PIC32MX330/350/370/430/450/470 Family Silicon Errata and Data Sheet Clarification

The PIC32MX330/350/370/430/450/470 family devices that you have received conform functionally to the current Device Data Sheet (DS60001185C), except for the anomalies described in this document.

FIGURE 1:

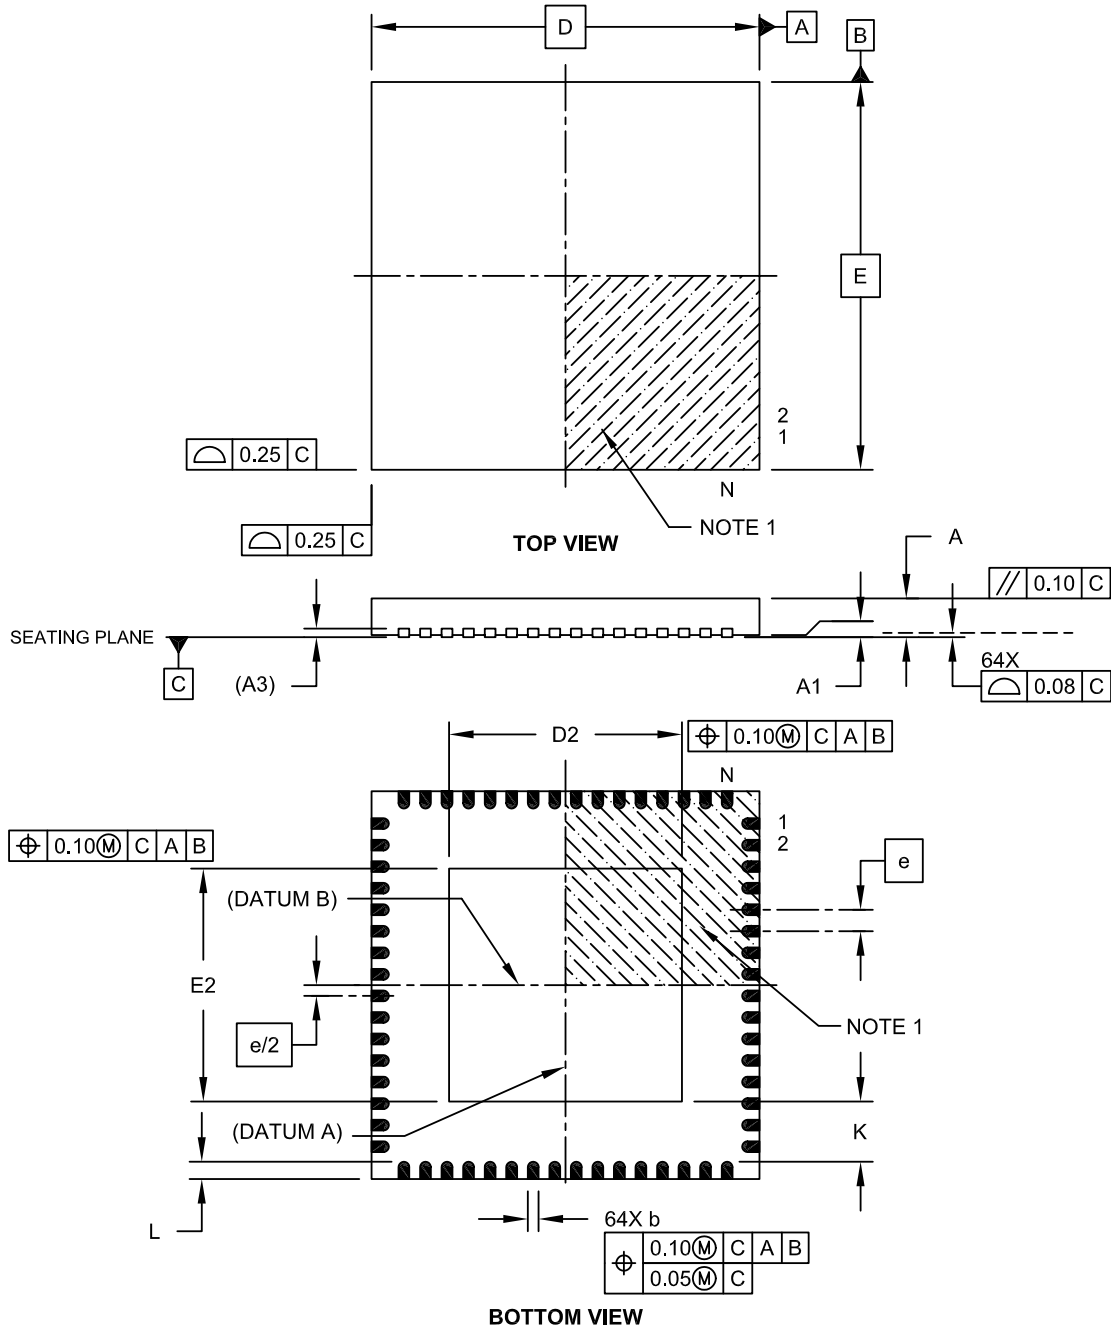
The 64-Lead QFN package detail drawings in the data sheet are incorrect. Figure 1 through Figure 5 show the correct drawings.
